Security Light Wiring

Bulletin Type:	TSB	Publication Date:	March 2026
Bulletin #(s):	26-008	Make(s):	Entegra Coach
Job Code(s):	9803649	Model(s):	Centurion
Flat Rate(s):	9803649 – .30 HR – Security Light rewire and replacement	Model Year(s):	2026

Technical Service Bulletin Notification TSB #: 26-008

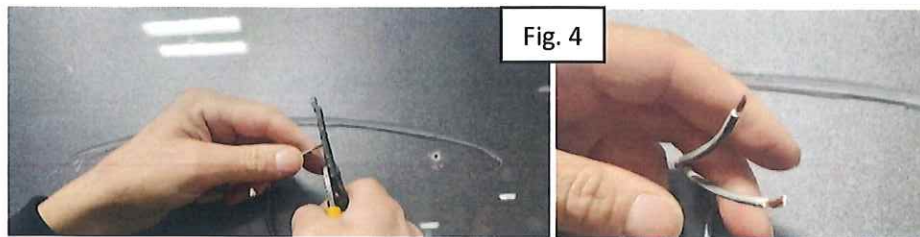
3. Cut the wires, one at a time, before the butt connectors, for the Red (From Light) to White (From Coach), Black (From Light) to Gray with Yellow stripe (From Coach), & White (From Light) to Brown with Red stripe (From Coach). (Figure 3)

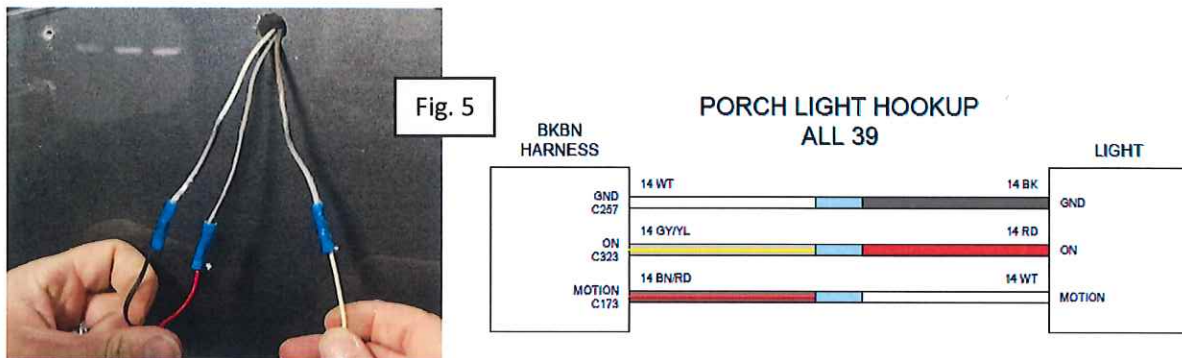
- Strip the wires coming from the coach. (Figure 4)

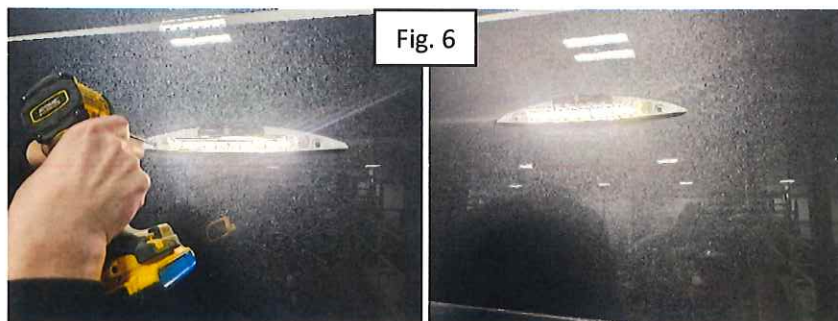
- Use butt connectors to connect the new light to the existing wires from the coach. The Black wire (From Light) will be connected to the White wire (From Coach), the Red wire (From Light) will be connected to the Gray with Yellow Stripe wire (From coach), & the White wire (From Light) will be connected to the Brown with Red stripe wire (From Coach). (Figure 5)

Fig. 8

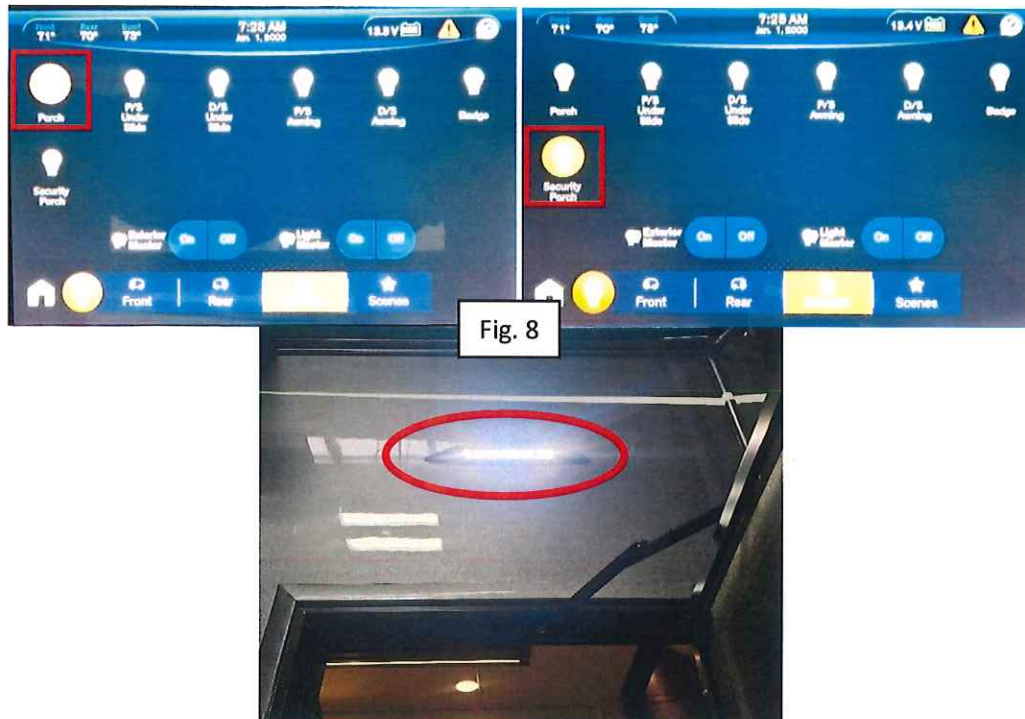
9. Test the light for functionality.

- a. **Note: You will want to test both the Porch and Security Porch lights. They will operate independent of one another.** (Figure 8)
